U.S. DEPARTMENT OF
ENERGY

Subject: Transmittal of the Part B Permit Application for Renewal of the Los Alamos National Laboratory Hazardous Waste Facility Permit, EPA ID #NM0890010515

Figure 8 TA-50 Location Map Showing Security Fences and Entry Gate

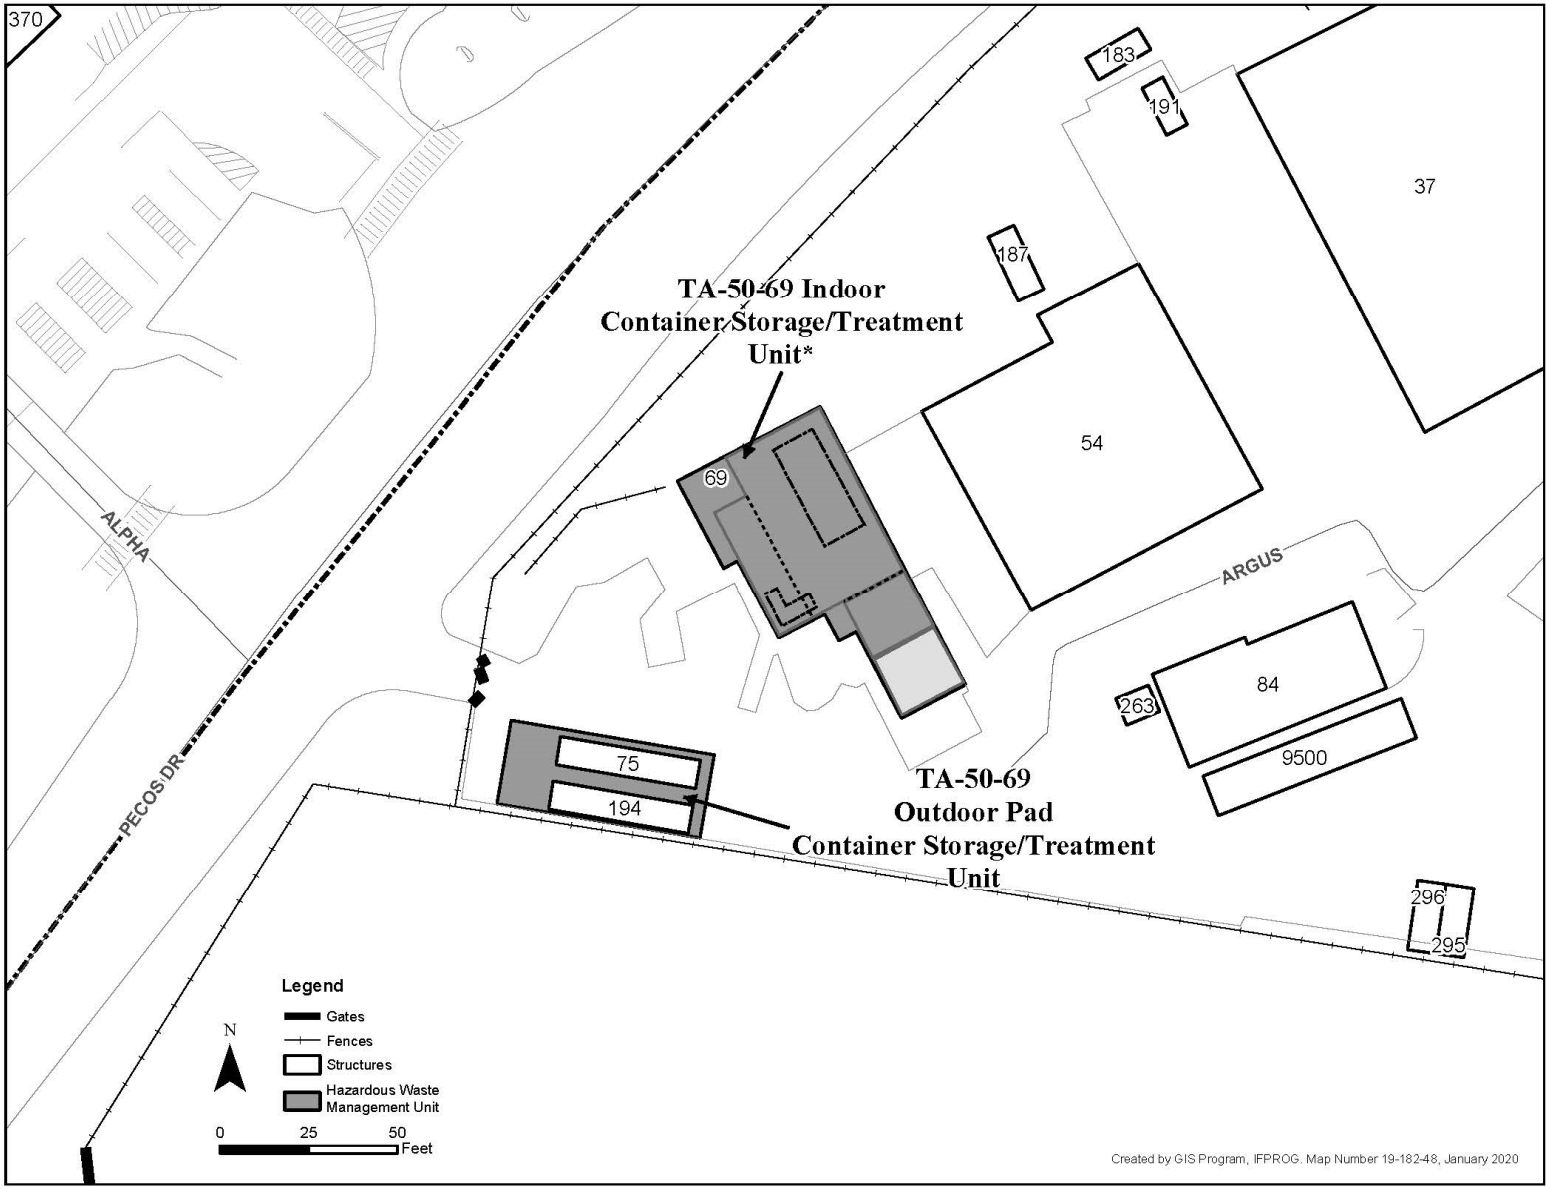
Figure 8 TA-50 Location Map Showing Security Fences and Entry Gate	Replaces Figure 6 and Figure 23	Propose to renumber Figure 8 (TA-54, Area G, location and security) in the current 2010 Permit to new Figure 10 and replace with a new Figure 8 for the TA-50 location and security.	The Permittees propose to rearrange the order of figures to insert the proposed new units and for consistency. Former Figure 8 is now Figure 10. The figure has been updated to depict the one gate at TA-50 for security.
Figure 9 TA-54, Area L, Location Map Showing Security Fences, Entry Gates, and Entry Stations	Figure 7 and Figure 26	Propose to renumber Figure 7 in the current 2010 Permit to Figure 9 (Technical Area 54, Area L, Security Fences, Entry Gates, and Entry Stations). No changes were made to the figure, however, the title of the figure was updated for consistency. Removal of redundant Figure 26 in the current 2010 Permit is also proposed.	The Permittees propose to rearrange and renumber figures to align with proposed changes and place the TA-location maps and security figures in order.

Figure 10 TA-54, Area G, Location Map Showing Security Fences, Entry Gates, and Entry Stations

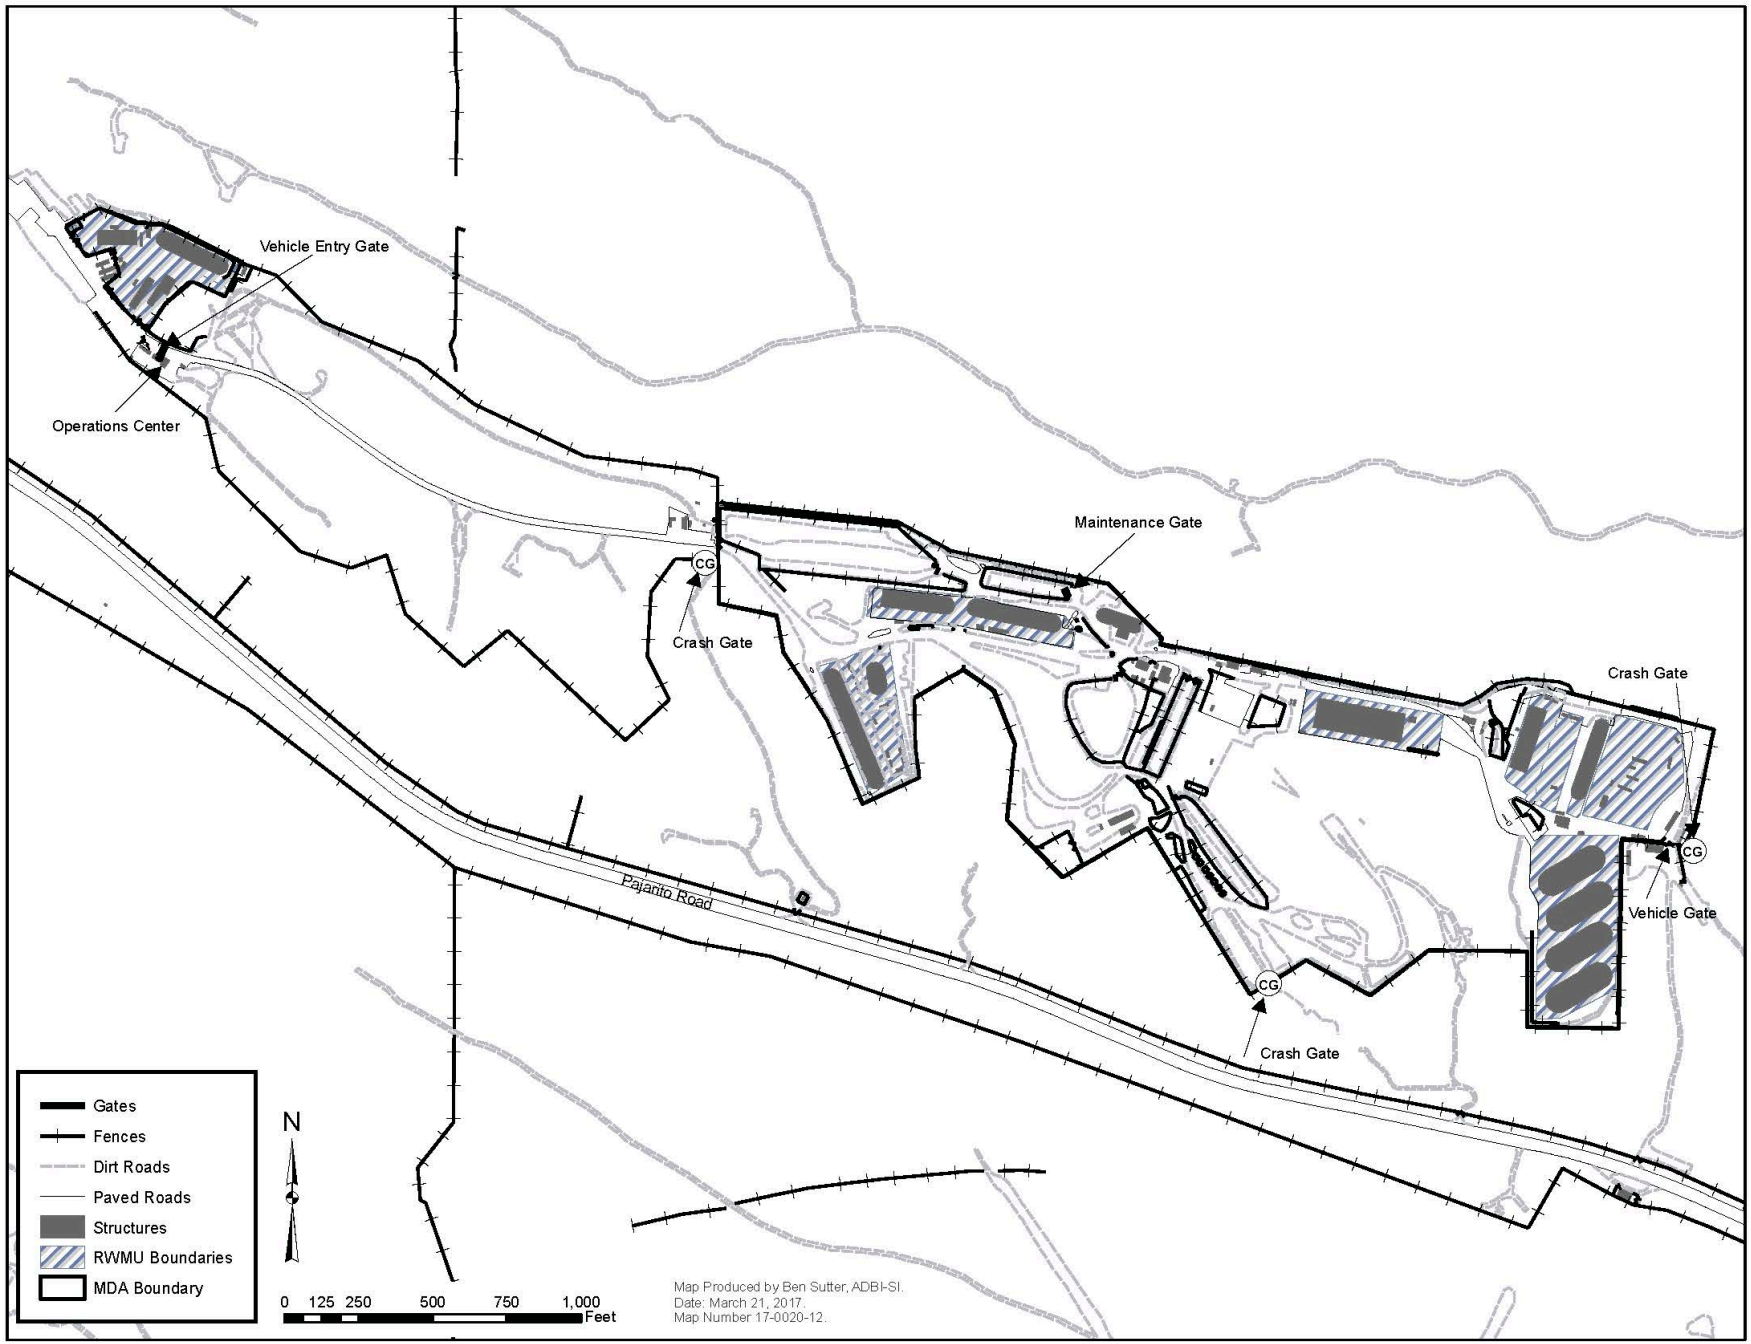
New Figure Number	2010 Permit Figure Number(s)	Proposed Modification	Justification
Figure 10 TA-54, Area G, Location Map Showing Security Fences, Entry Gates, and Entry Station	Figure 8	Propose to renumber Figure 8 in the current 2010 Permit to new Figure 10 (Technical Area 54, Area G, Security Fences, Entry Gates, and Entry Stations). No changes were made to the figure, however, the title of the figure was updated for consistency.	The Permittees propose to rearrange and renumber figures to align with proposed changes and place the TA-location maps and security figures in order.
Figure 11 TA-54 West Location Map Showing Security Fences, Entry Gates, and Entry Stations	Figure 9 and Figure 37	Propose to renumber Figure 9 in the current 2010 Permit to new Figure 11 (TA-54 West Location Map Showing Security Fences, Entry Gates, and Entry Stations). The figure has been updated to reflect the allowed treatment at the outdoor unit and the title of the figure has been updated for consistency. Removal of redundant Figure 37 in the current 2010 Permit is also proposed.	The Permittees propose to rearrange and renumber figures to align with proposed changes and place the TA-location maps and security figures in order.

Figure 12 TA-55 Location Map Showing Security Fences and Entry Gates

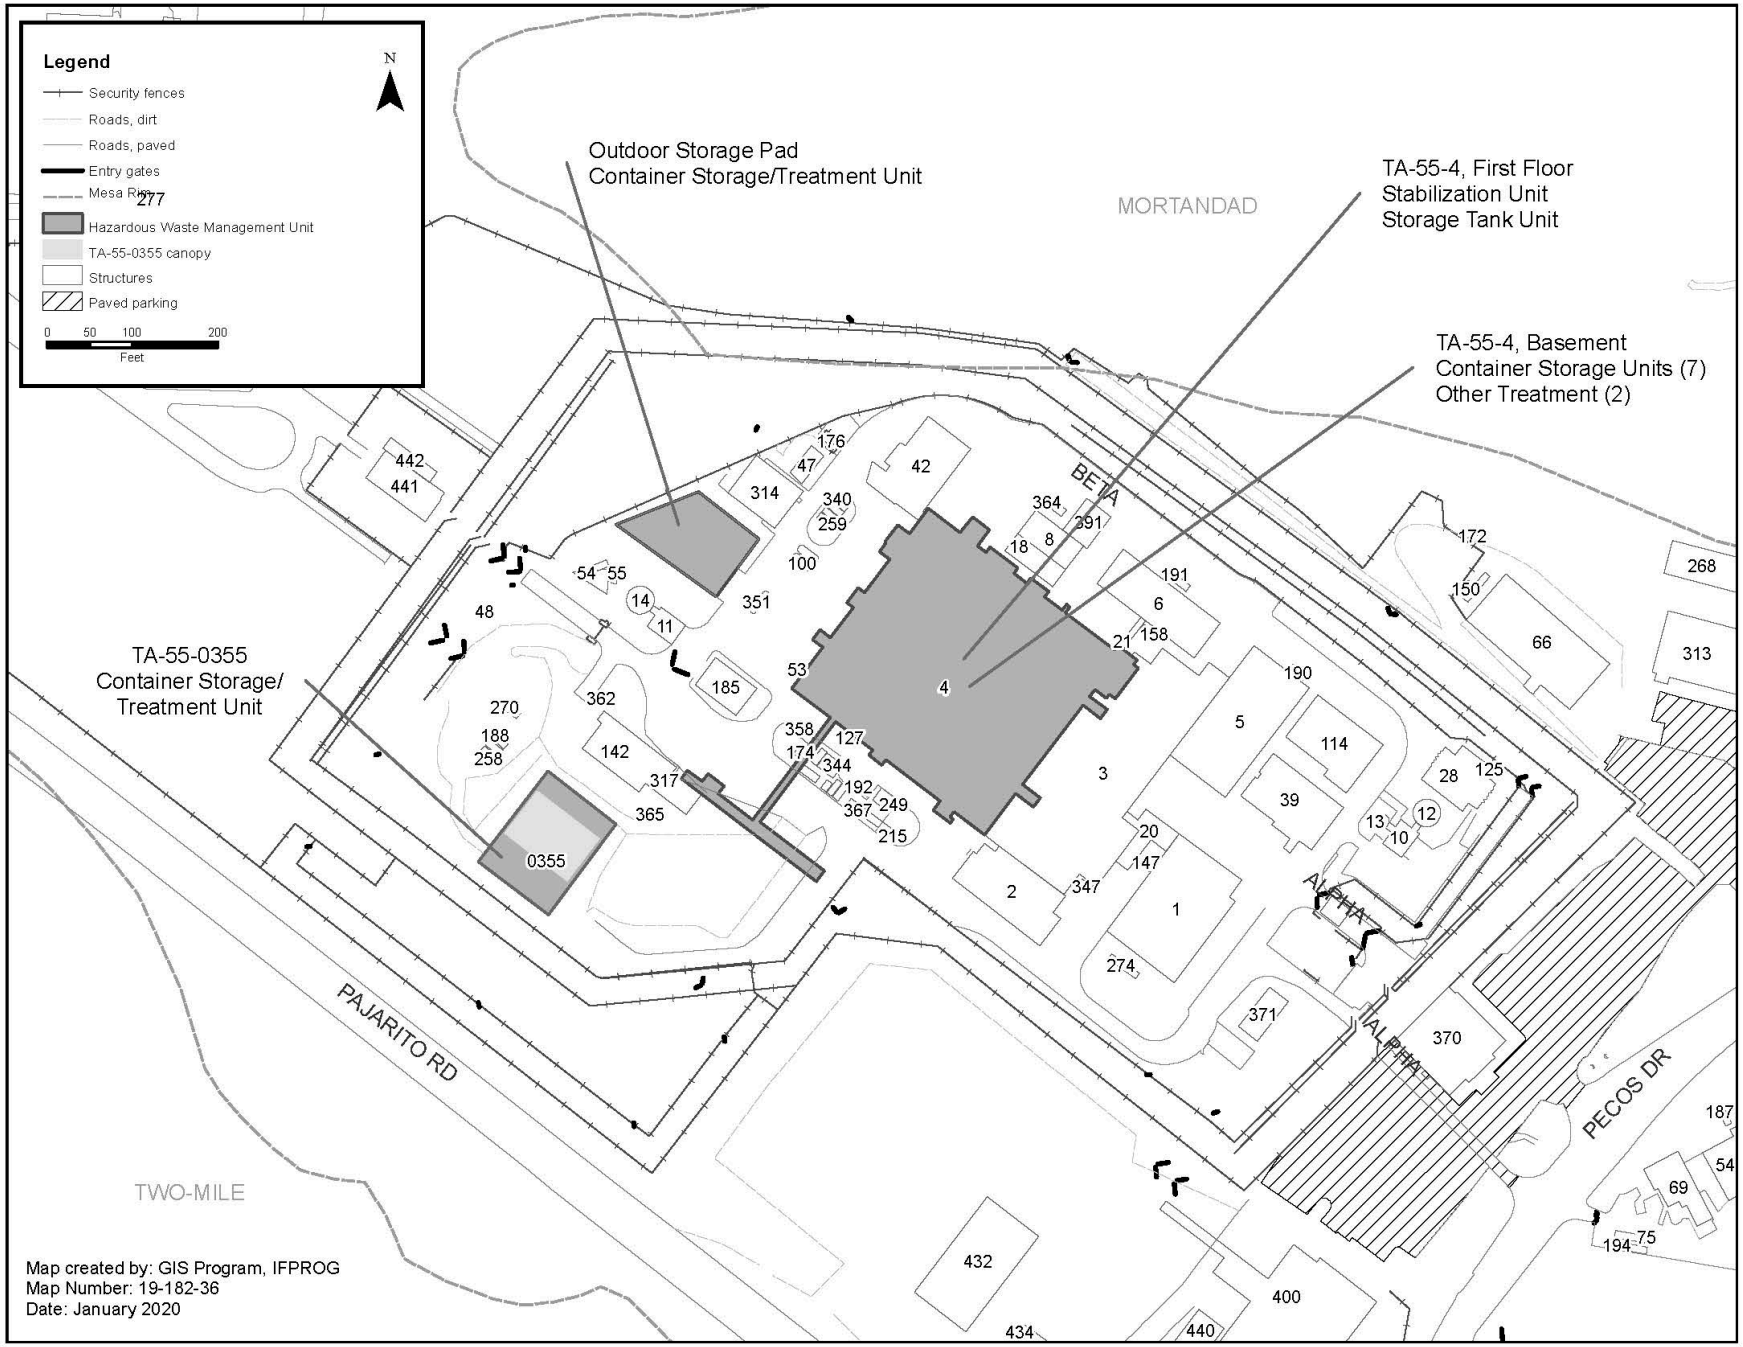
Figure 12 TA-55 Location Map Showing Security Fences and Entry Gates	Figure 10 and Figure 39	Propose to renumber Figure 10 in the current 2010 Permit to new Figure 12 (TA-55 Location Map Showing Security Fences and Entry Gates). The figure has been updated to reflect the allowed treatment at several units and the title of the figure has been updated for consistency. Removal of redundant Figure 39 in the current 2010 Permit is also proposed.	The Permittees propose to rearrange and renumber figures to align with proposed changes and place the TA-location maps and security figures in order.
Figure 13 TA-63 Transuranic Waste Facility Location Map Showing Security Fences, Entry Gates, and Vehicle Barriers	Figure 55	Propose to renumber Figure 55 in the current 2010 Permit to new Figure 13 (TA-63 Transuranic Waste Facility Location Map Showing Security Fences, Entry Gates, and Vehicle Barriers). The figure has been updated to reflect the allowed treatment at the unit and the title of the figure has been updated for consistency.	The Permittees propose to rearrange and renumber figures to align with proposed changes and place the TA-location maps and security figures in order.

Figure 14 TA-3 Chemistry Metallurgy Research (CMR) Building Basement Layout

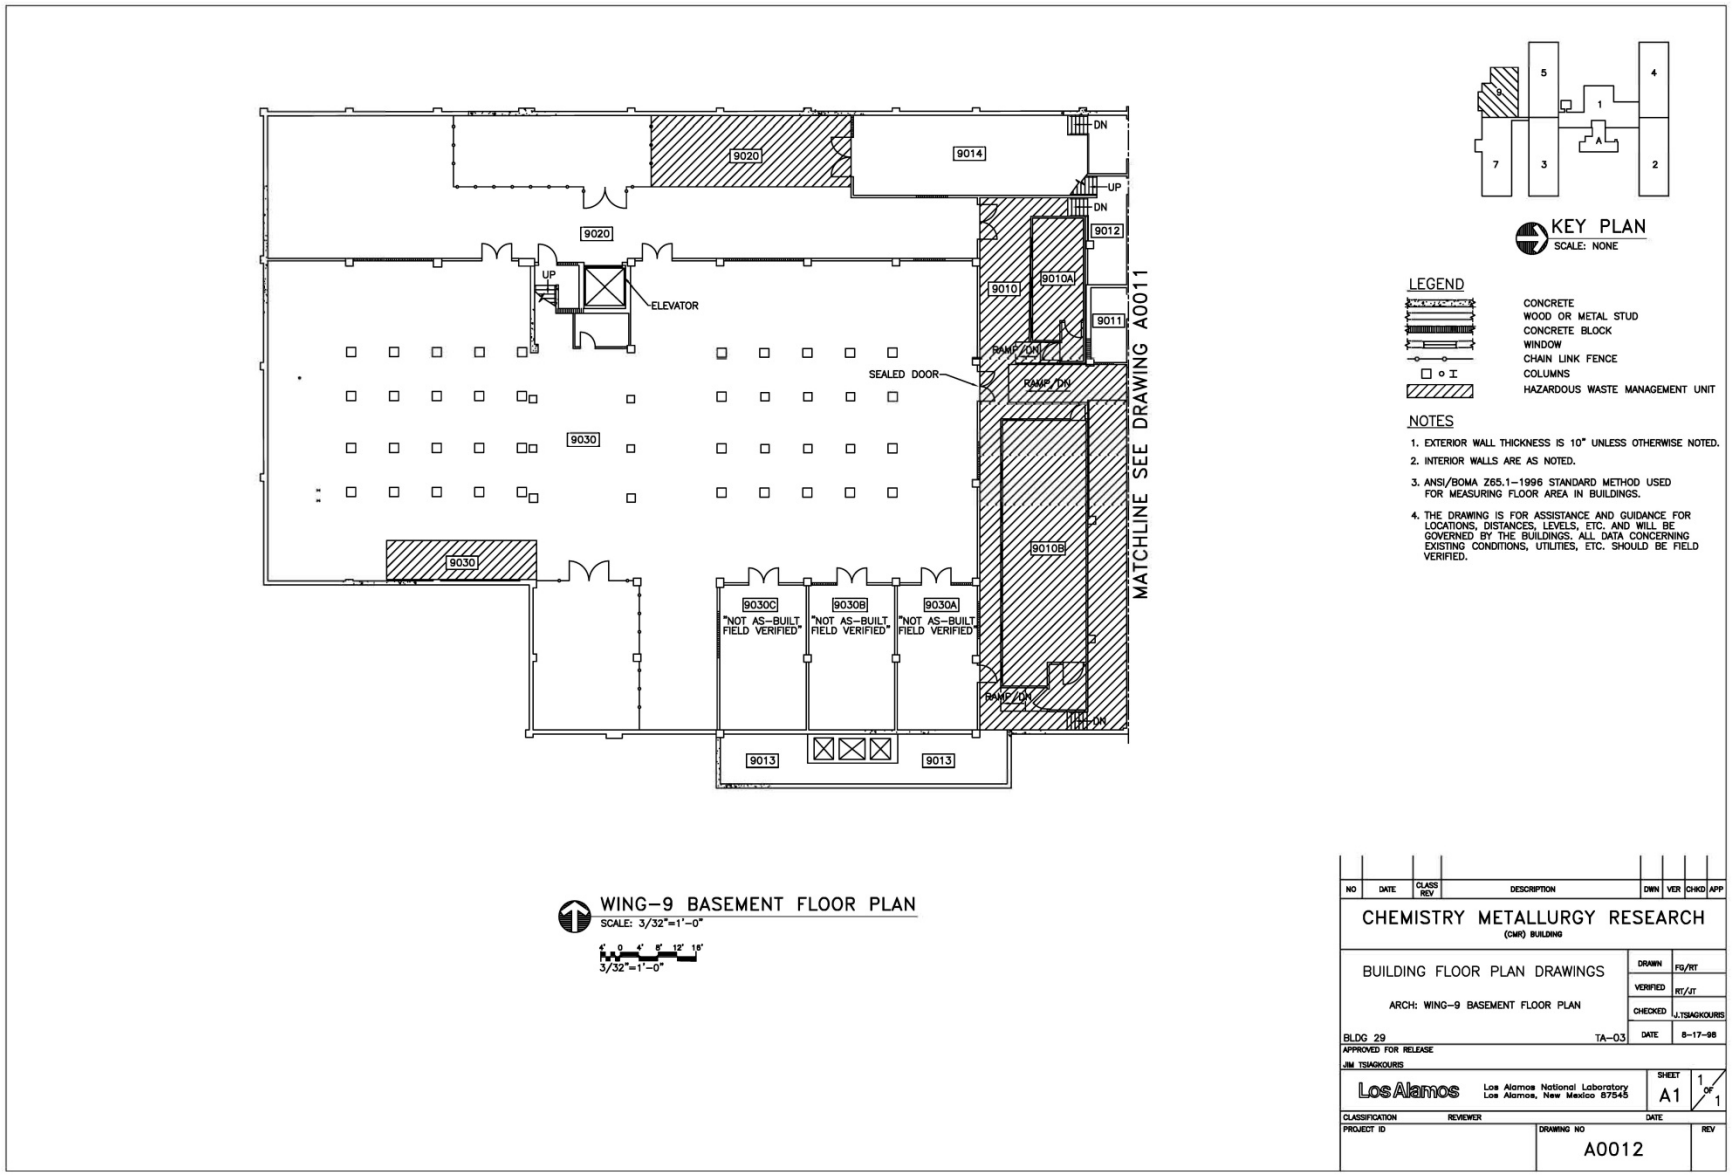
New Figure Number	2010 Permit Figure Number(s)	Proposed Modification	Justification
Figure 14 TA-3 Chemistry Metallurgy Research (CMR) Building Basement Layout	Figure 13, Figure 14, and Figure 15	Propose to replace old Figures 13 through 15 with a single figure for the TA-3 Chemistry Metallurgy Research (CMR) building basement layout that depicts all of the units in one figure.	The Permittees also propose to insert an updated figure here for the CMR basement units figure.
Figure 15 Diagram of the TA-16-388 Flash Pad Showing Location of Burners and Retractable Metal Roof	New figure	Propose to insert new figure diagram of the TA-16-388 Flash Pad showing the location of the burners and the metal roof to depict the proposed open burning unit.	The Permittees propose a new figure to illustrate the design of the proposed open burning unit.
Figure 16 TA-54, Area G, Container Storage Unit	Figure 27	Propose to renumber Figure 27 in the current 2010 Permit to new Figure 16 (Technical Area 54, Area G, Container Storage Unit). No changes were made to the figure, however, the title of the figure was updated for consistency.	The Permittees propose to rearrange and renumber figures to align with proposed changes and reduce redundancy within the attachment.
